Catherine Reheis-Boyd
President

December 3, 2019

Re: WSPA Comments on CARB Proposed Control Measure for Ocean-Going Vessels at Berth

Figure II-2: Health Risk – A Relative Perspective

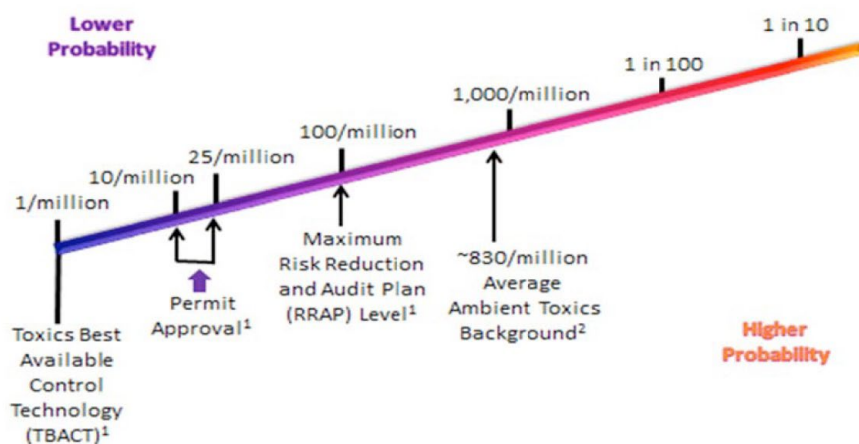
In contrast to the 2015 Risk Management Guidance, in the ISOR Staff concludes that “[e]missions from ocean-going vessels operating at berth are a significant and growing contributor to community air pollution and associated health impacts.” ISOR, p. VI-1. However, nowhere does Staff compare the emissions or potential health impacts attributable to OGVs at-berth with other sources of criteria air pollutants or toxic air contaminants that Californians are exposed to each day. For example, the ISOR indicates that baseline (2016) maximum exposed individual incremental cancer risk (MEIR) attributable to ships at-berth is 74-in-a-million at the Ports of Los Angeles and Long Beach (POLA and POLB), and 16-in-a-million at the Richmond Complex (the Port of Richmond and the Chevron refinery berths). ISOR, p. V-14. While these incremental risks apply to individuals living within a relatively small distance from these two port complexes, CARB estimates that the average individual living in California is exposed to an incremental cancer risk attributable to diesel particulate matter (DPM) of approximately 520-in-a million.¹⁷

Furthermore, as the following graphic (from CARB’s 2015 Risk Management Guidance) shows, CARB recommends development of a risk reduction plan if calculated risk levels exceed 100-in-a-million.¹⁸ The At Berth Regulations ignore these guidelines by, in effect, imposing a risk reduction plan on a collection of sources (such as a port complex) at much lower levels, when such a plan would not be required for an individual stationary source with the same calculated risk level.

Figure 1-1: Forecast of percentage of Tier III vessels capable of calling at RLW by year
(Source: Chevron forecast using Clarkson's commercially available fleet database, factoring in vessel clearance procedures)

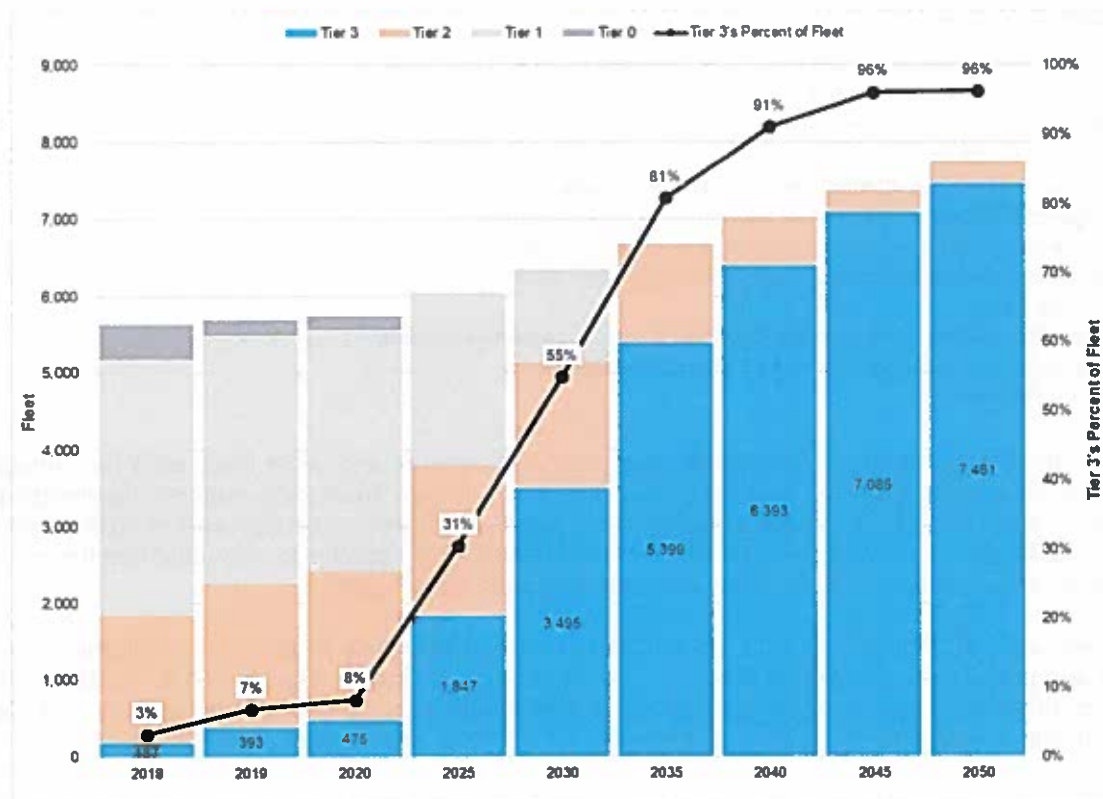
More specifically, Chevron built two Suezmax-sized tankers that are used to lighter nearly 70% of Richmond Refinery's crude deliveries to the RLW. These two lightering vessels have keel-laid dates in 2013 but were designed to be able to operate their electrical generation at RLW in low-emission mode by using superheated steam auxiliary boilers and turbogenerators, which do not produce diesel particulate matter (DPM) and have a much lower NOx emissions than Tier III diesel engines. In fact, according to a boiler burner maker, marine boiler NOx emissions are 0.78g/kWh, significantly lower than the Tier III limit for a 900 rpm diesel generator which is 2.31g/kWh www.volcano.co.jp/english/pdf/Volcano_TCS_Bulletin_004PB.pdf. As of 2018, these vessels, with NOx emissions below Tier III levels, represent a considerable amount of our annual at berth emissions (70% of our crude deliveries are via Suezmax-sized vessels).

Our study concluded that 55% of vessels calling at RLW would be expected to be Tier III compliant by 2030, and 80% of vessels would be Tier III compliant by 2035. In addition to our analysis, an independent 3rd party conducted a similar analysis and demonstrated similar results – about 50% of vessels by 2030. With two independent data evaluations, we believe the Starcrest (2017) report is erroneous and calls into question the entire purpose of the proposed at berth regulation. If nearly 80% of vessels calling at Northern California Marine Terminal Complexes owned/operated by major oil companies will be Tier III-compliant by 2035, then this regulation will have less than 5 years of relevance toward achieving its target emission reductions before vessel-side technologies meet or exceed the 80% control factor. Further, on-board emission controls will exceed the magnitude of reductions capable with at berth controls, because on-board controls will benefit the entire Emission Control Area (ECA) during transit and maneuvering. Consequently, the cost-effectiveness of this proposed at berth regulation appears to be very low.

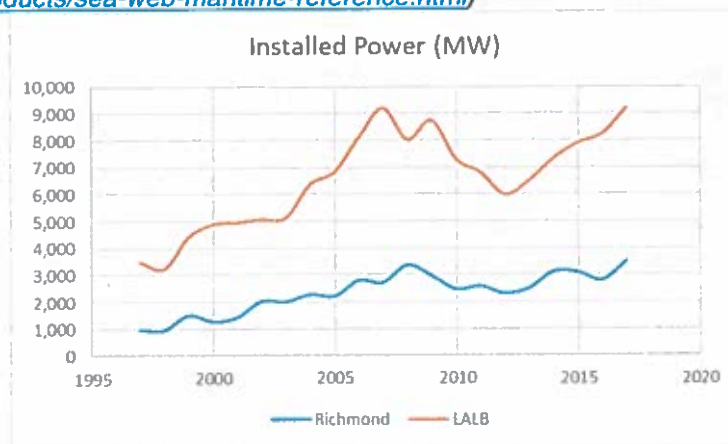
The installed power (determined from the U.S. Army Corps of Engineers Foreign Vessel Entrances and Clearances data as calls time propulsion power in MW) for vessels calling at POLA/POLB is nearly a factor of 3 greater than RLW.

Figure 4-1: Richmond Actual Vessel Calls By Year, 2007-2017

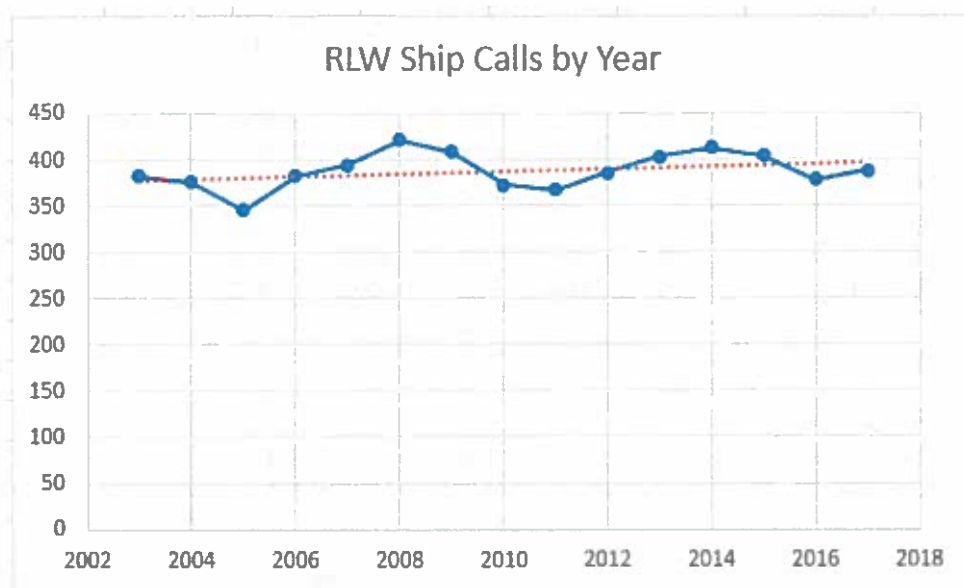
Figure 4-1, below, demonstrates that RLW historical 2007-2017 vessel calls did not escalate continuously, but rather are cyclical, and primarily driven by operational and maintenance activities within the refinery itself.

Consequently, CARB should not rely upon the FAF Report as a future forecast for vessel activity for RLW and the Richmond Refinery. Based on our past 10 years operation, we would not expect greater than 1% growth over a 10-year period. Forecasting it to 2040, that would equate to a vessel growth rate of 1.03 (3% relative to 2016).

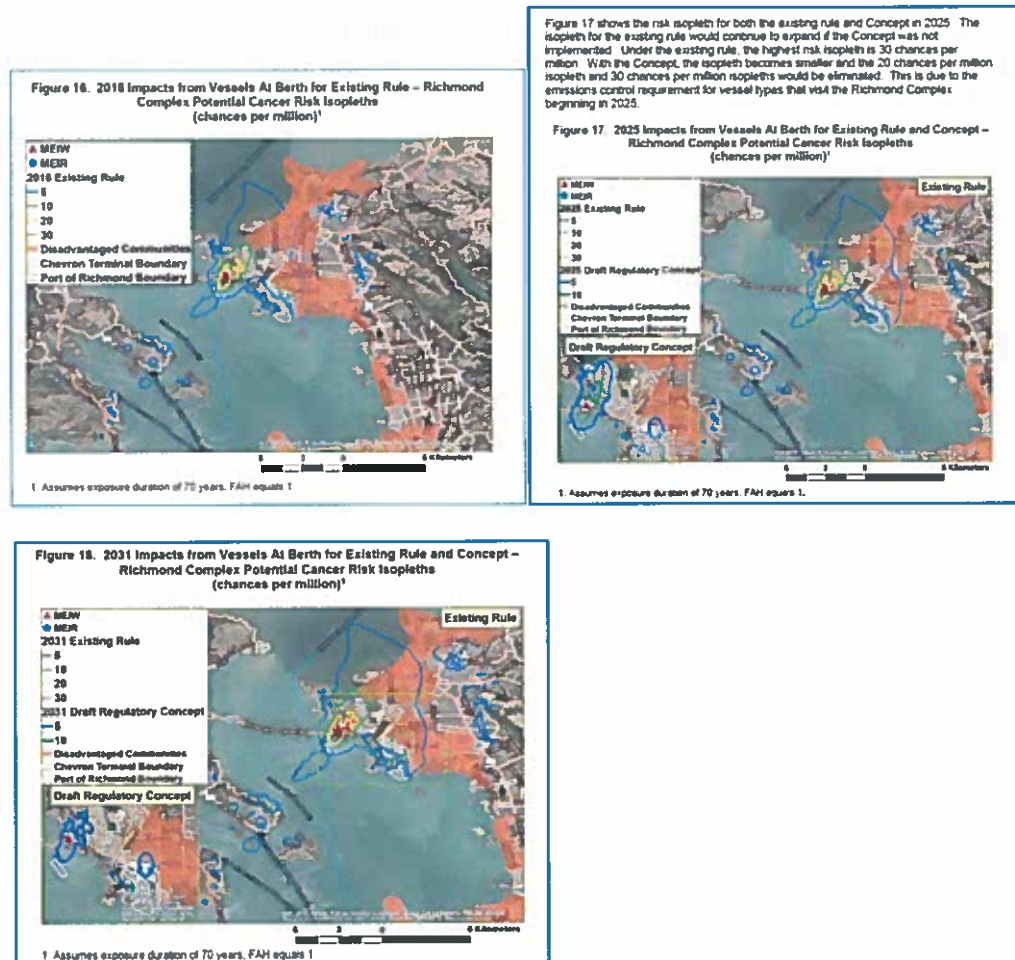
Although the HRA methodology appears sound, the underlying emissions data inputs are incorrect. This results in incorrect estimates of health risks.

Health Risk Assessment Figures 16 through 18 illustrate the locations of the MEIR (based on a 30-Year exposure duration) and the MEIR (based on a 25-year exposure duration). The isopleth illustrating the extent of the cancer risks are based only on a 70-year exposure duration. This mixed presentation can be misleading to the general public. Using the 70-year exposure duration assumes that all populations would be living in this same location for 70 years. Although the Risk Management Plan Guidance (CAPCOA, 2015) states that for the population-based cancer risk calculations one should use a 70-year exposure duration, it also states that “studies show that a 30-year exposure duration is a reasonable estimate of the 90th and 95th percentile of residency duration in the population.” A 30-year exposure duration isopleth figure should also be included to represent a more realistic spatial estimate of cancer risk. It is also recommended that separate isopleth figures be added to represent a 9-year exposure period and a 25-year worker exposure duration.

Figure II-2: Health Risk – A Relative Perspective

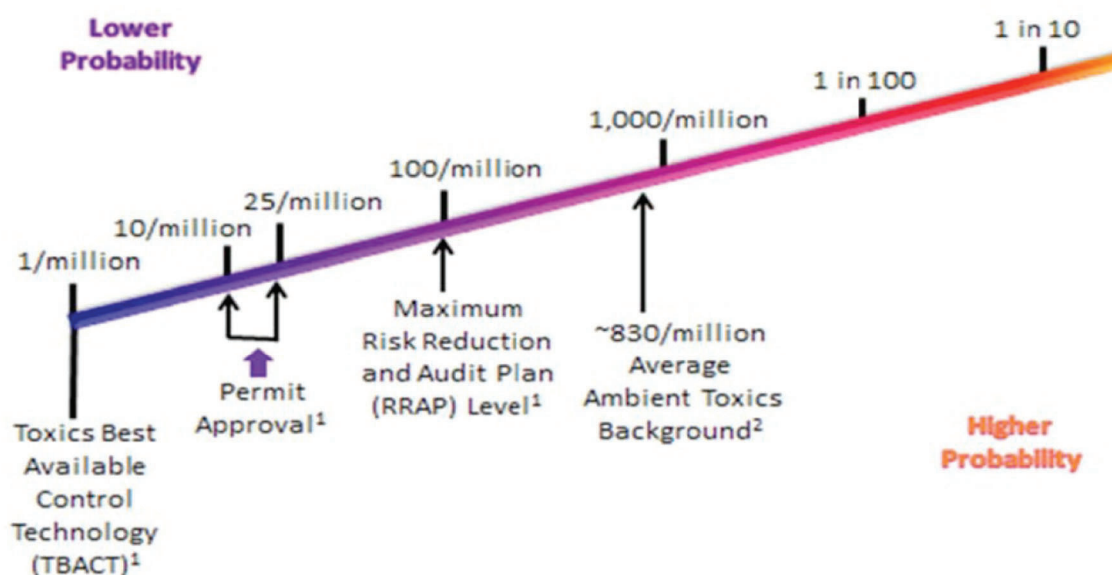
3. CARB’s assertion that the proposed regulation would avoid “health impacts valued around \$2.3 billion”⁵ is not supported by sound science.
